SERVICE BULLETIN

M-1137

VOLTAGE REGULATOR INFORMATION UPDATE

To communicate a need for dealers to make corrections to the Electrical Diagnostic manuals of models with series style voltage regulator/rectifier.

Figure 1-1. Voltage Regulator

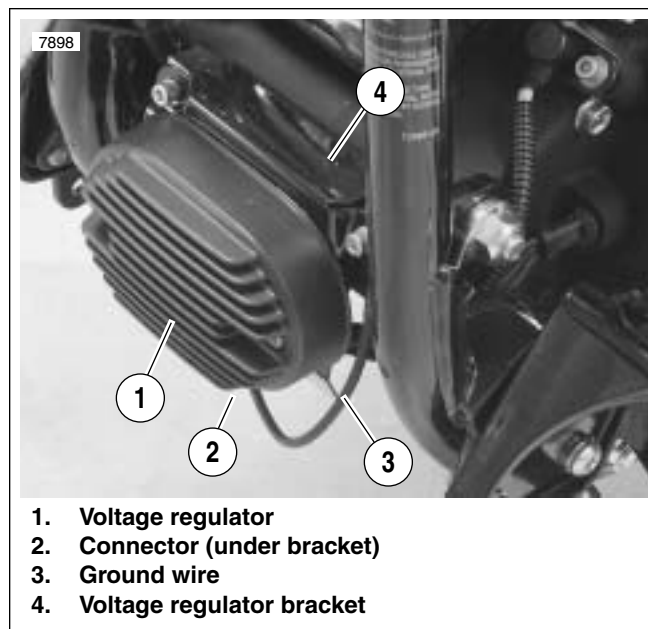
- In Section 1.7 under General, the voltage regulator is referred to as "a series regulator with shunt control." Remove the phrase "with shunt control."
- In Section 1.7 under Troubleshooting, the technician is instructed to test that the regulator/rectifier base is grounded. The regulator is not grounded at the base. The regulator is grounded by a wire that is connected to the regulator mounting bracket.

See Figure 1-1. To test if voltage regulator (1) is grounded, check that ground wire (3) leading from the regulator to the regulator bracket (4) has a good ground. Also check that the voltage regulator connector (2) is clean and tight.

Figure 1-2. Voltage Regulator Grounding Fastener

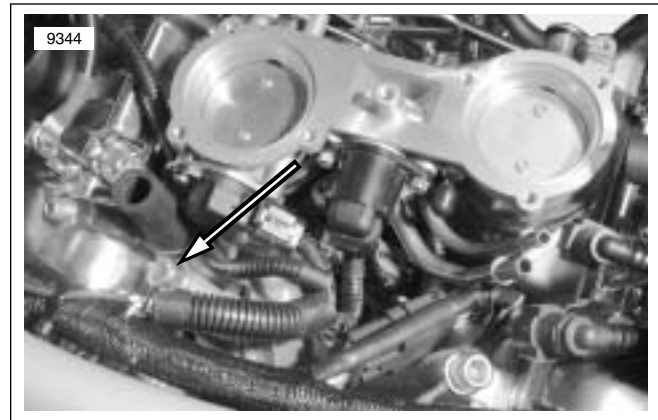
- In Section 1.7 under General, the voltage regulator is referred to as “a series regulator with shunt control.” Remove the phrase “with shunt control.”
- In Section 1.7 under Troubleshooting, the technician is instructed to test that the regulator/rectifier base is grounded. The regulator is not grounded at the base. The regulator is grounded by a wire that is routed to the ground at the rear of the front cylinder head.

See Figure 1-2. To test if voltage regulator is grounded, check that ground wire leading from regulator to front cylinder head has a good ground.

Test 1.7 (Part 1 of 2)

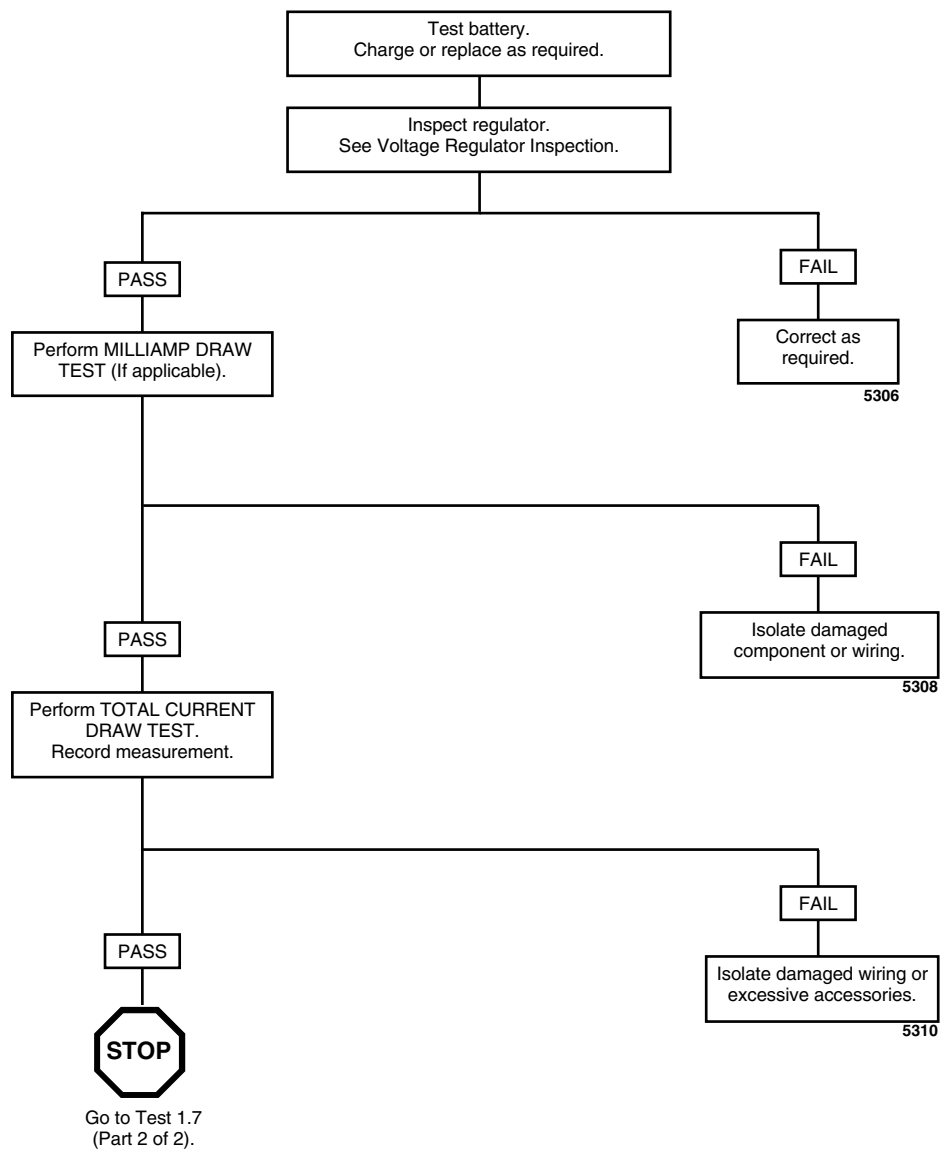
- In Section 1.7, replace page containing Test 1.7 (Part 1 of 2) of both manuals with a copy of page 3 of this bulletin.
- In Section 1.7 under Testing, remove the Regulator Bleed Test from the manuals.
